# **Civil SSDA - Flood Assessment & Stormwater Management Report**

**Lang Walker AO Medical Research  
Building - Macarthur**

Prepared for **BVN** / 25 March 2022

## Response to EES Comments

Figure A1 - Existing Overland Flow Path at Southern Site Boundary

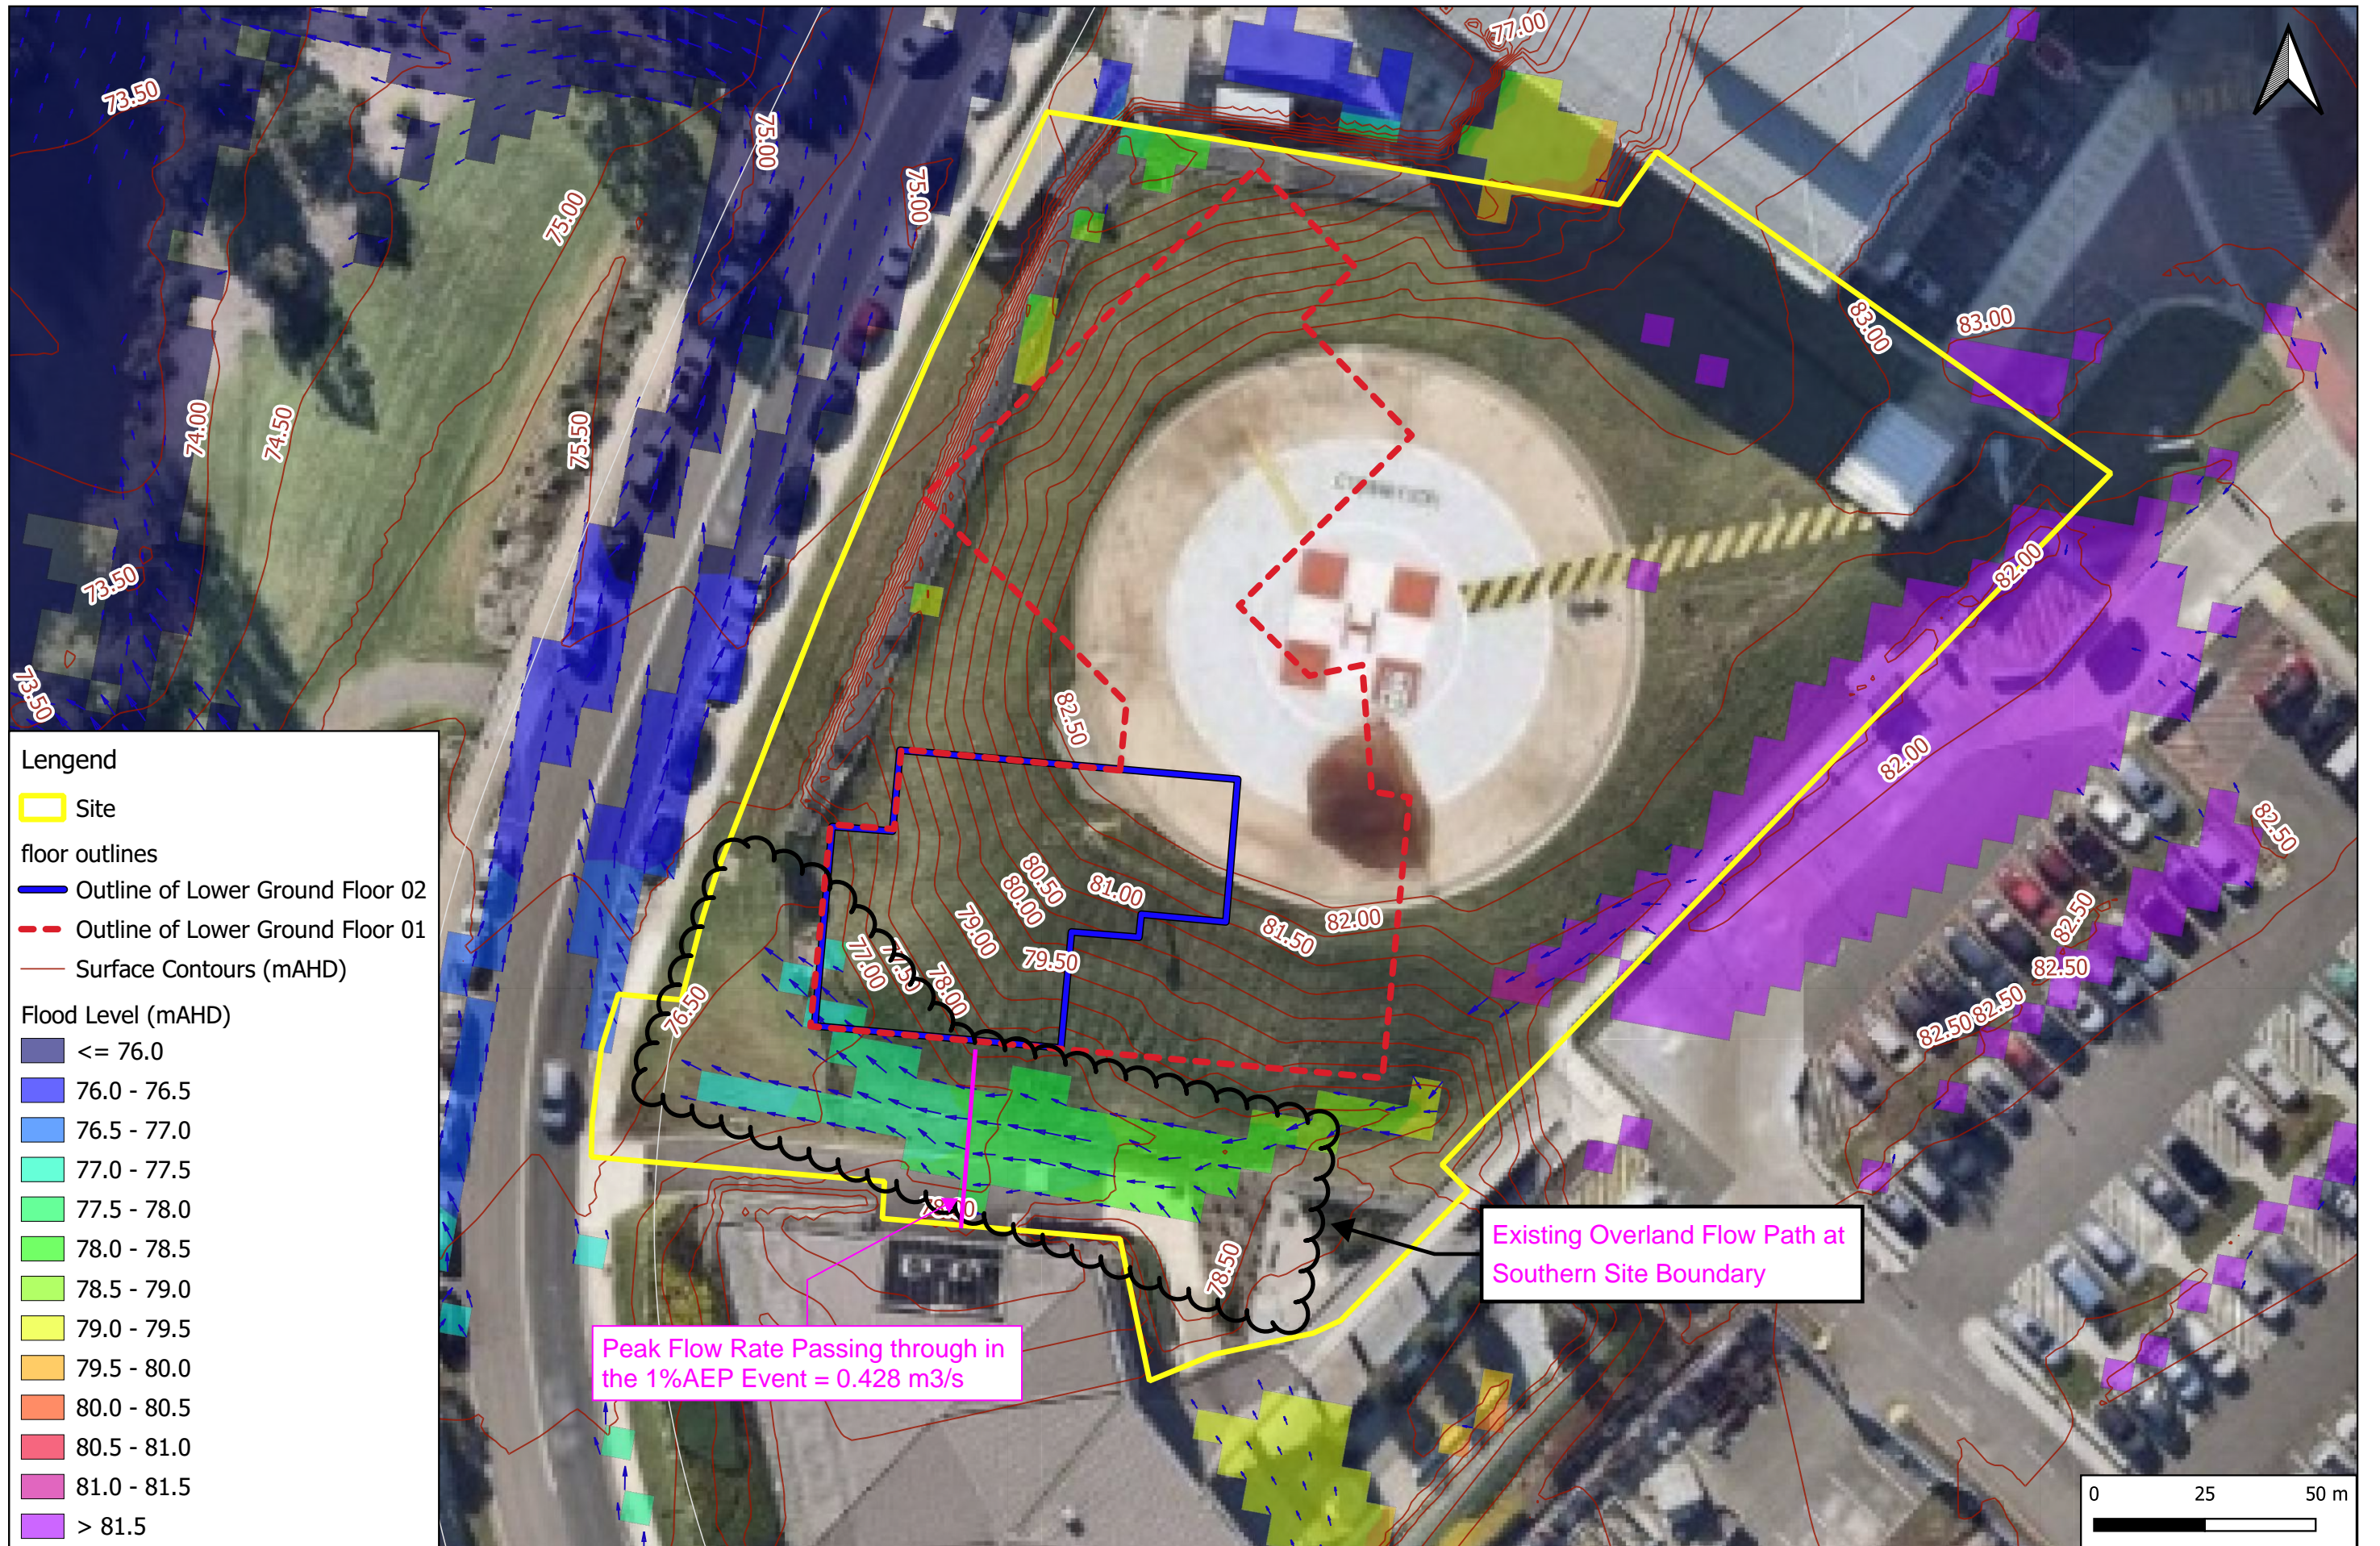
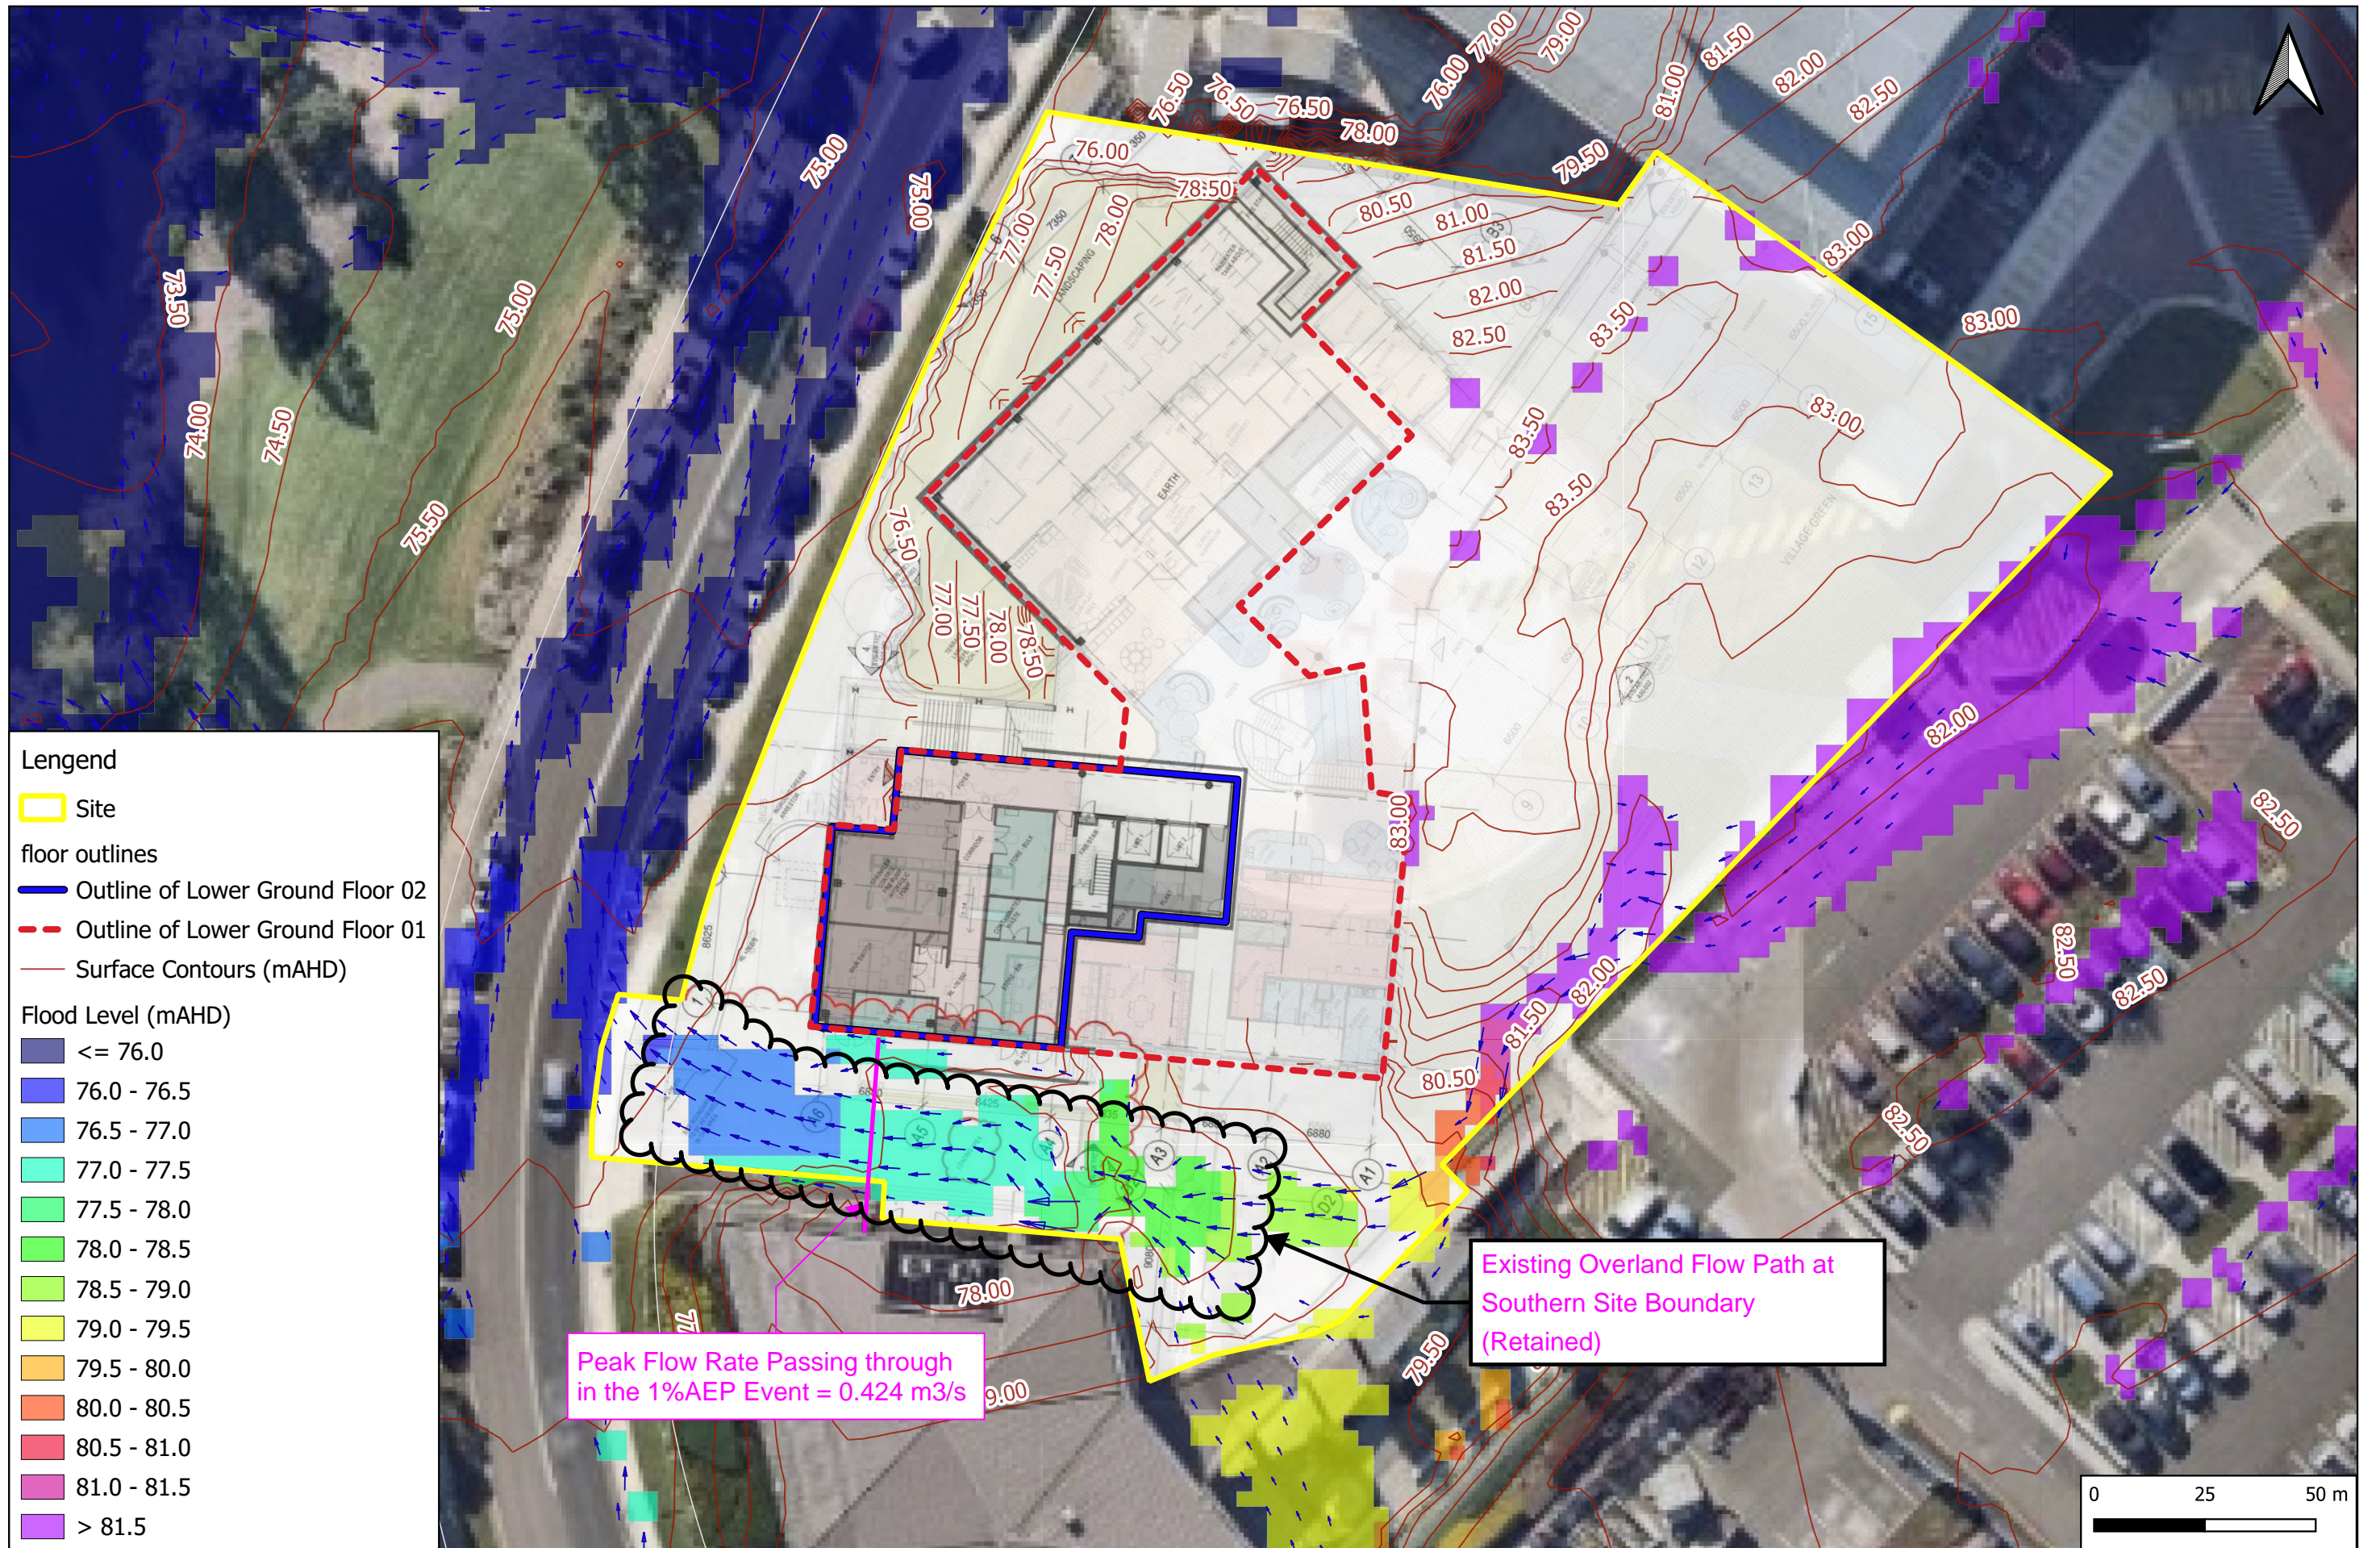
Campbelltown Council Comments	TTW Response
<ul style="list-style-type: none"> <li>▪ The site is impacted by overland flow from the car park at the hospital. Council discussed this matter with the proponent's engineers previously, and it was indicated that an overland flow path to the north of the proposed building would be included in the design. This flow path is not evident on the plans, However it is needed and should collect the overland flow and manage its discharge to the pipe drainage system in Parkside Crescent. Overland flows over the footpath, or discharge to the road surface are not permissible.</li> </ul>	<ul style="list-style-type: none"> <li>▪ The existing overland flow path for the upstream catchment (including the existing car park east of the site) is along the southern site boundary which drains onto the Crescent Park Road as shown in Figure 8 and presented clearly in Figure A1 of Attachment A.</li> <li>▪ The existing overland flow path has been maintained in the proposed development along the southern site boundary (see Figure 16 and Figure A2 of Attachment A).</li> <li>▪ The proposed pipe drainage system for the site is designed to cater for storm events of up to 5% AEP (minor event) as per the ARR minor and major drainage system requirements.</li> <li>▪ Minor storm event for the site is identified based on Table 4.5 of the Campbelltown Council DCP (2015).</li> <li>▪ The existing pipe network has been assumed to be fully blocked in the 1% AEP and PMF events. This approach provides more conservative results as opposed to the condition where the additional drainage capacity of the pipes is considered.</li> <li>▪ The existing stormwater pipe network in Parkside Crescent does not have capacity to convey the existing overland flows in major flood events e.g., a 1% AEP flood or greater.</li> <li>▪ The proposed development does not have any adverse impact on the existing flood levels or overland flow paths outside the development area, including the Parkside Crescent and the footpath.</li> <li>▪ The Proposed condition slightly reduces the 1% AEP existing overland flow that runs along the southern boundary, refer to Figure 25.</li> </ul>
